SERVICE BULLETIN

NUMBER: 09-115-24R

SUBJECT: Oxygen Sensor Design Change / P0137,
 P0138, P0140, & P0141

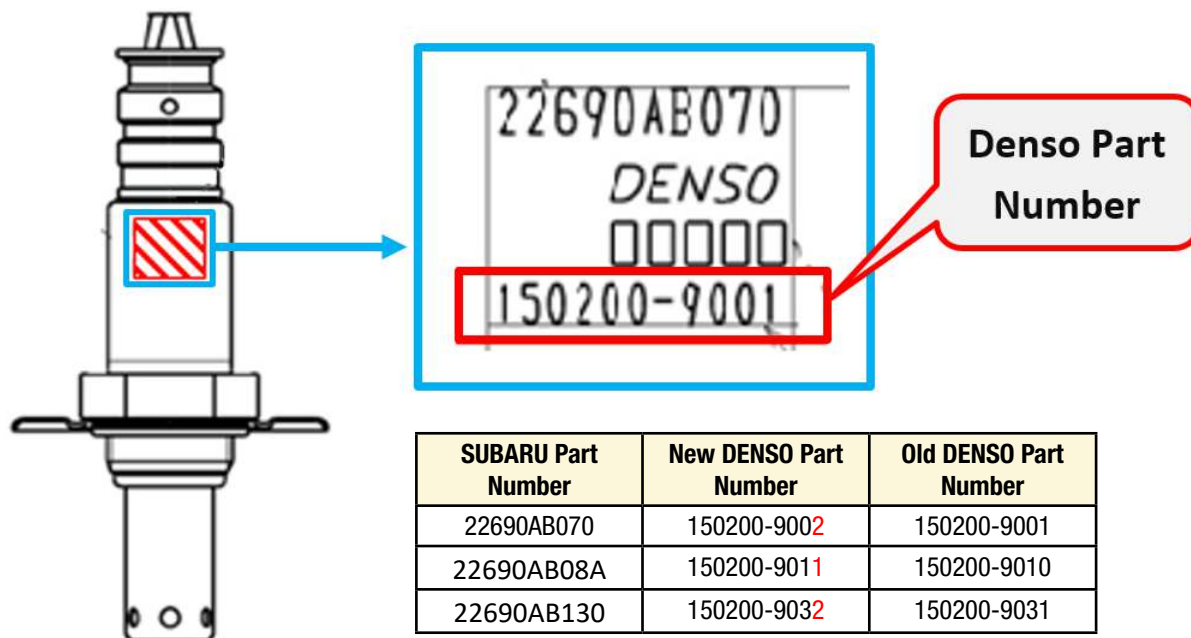
The new sensors have an optimized coating application to help prevent cracking within the internal surfaces reducing any possibility of short/open circuits. If any of the DTCs listed above are stored in the ECM, perform the sensor identification procedures outlined below.

The part numbers have not been changed. The new parts can be identified by the Denso part number engraved on the sensor.
